City of Poulsbo

Subject: Pinnacle at Liberty Bay PRD and Preliminary Subdivision | P-06-20-25-03 | Request for Revisions

To: Montebanc Management LLC
From: Nikole Coleman, AICP, Planning Manager
Subject: Pinnacle at Liberty Bay PRD; Request for Revisions No. 2; P-06-20-25-03
Date: December 31, 2025

To: Montebanc Management LLC, John Everett
From: Donald Washburn, Engineering Technician
Subject: Pinnacle at Liberty Bay Site Plan Application Submittal #2; P-06-20-25-03
Date: 12/19/2025

Fig 1. Site potential tree height at project site.

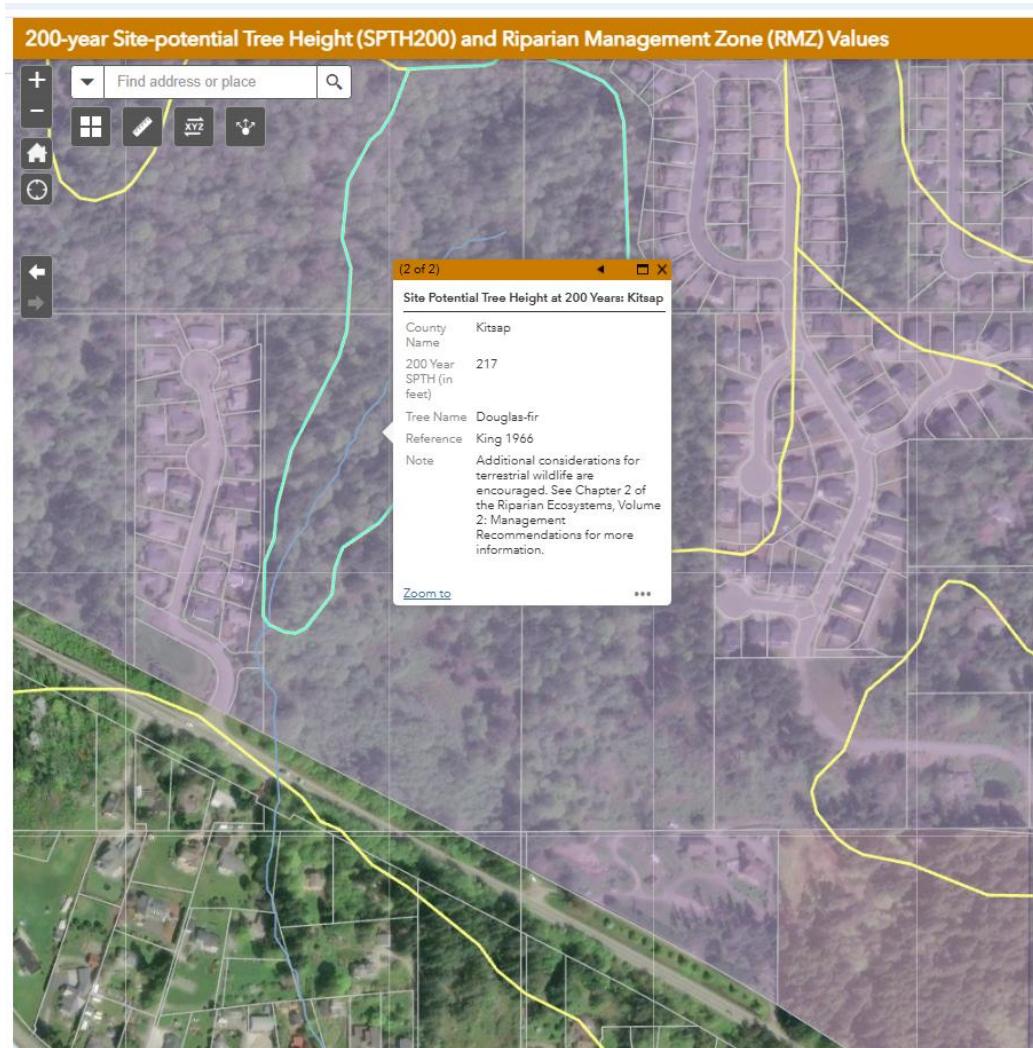
These documents recommend using a location's Site Potential Tree Height (SPTH) to determine buffer width, with the buffer width generally equal to the SPTH of a 200 year old tree. Site Potential Tree Height is the average maximum height of the tallest dominant trees for a given age and soil condition. SPTH at the project site is approximately 217 feet (Fig 1). *Riparian Ecosystems, Volume 2: Management Recommendations* (Volume 2) contains the following statement on page 8:

The applicant should not expect stream buffers less than the recommended minimum of 100 feet, will be sufficient to remove pollutants. Additionally, it should be assumed that any riparian buffer less than a SPTH is a *de facto* impact to the non-pollutant removal functions of the riparian area that should be considered during SEPA and other environmental review.

Fig 2. Location of mapped pocket estuary in relation to project site.

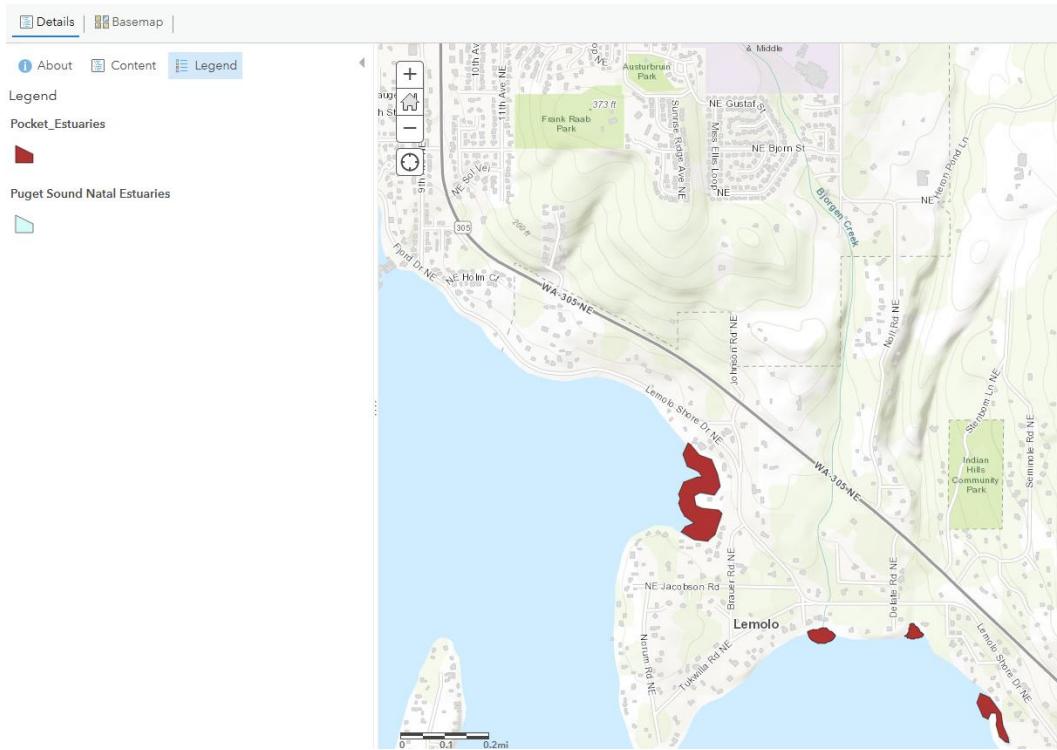
Furthermore, the marine area near where the streams traversing the project site discharge into Liberty Bay is mapped as a pocket estuary (Fig 2) and there are small deltas near the mouth of the Barrante’s Creek and stream D. As a result, considerable juvenile salmonid use, particularly coho and chinook, in this area is to be expected, increasing the probability some juveniles will
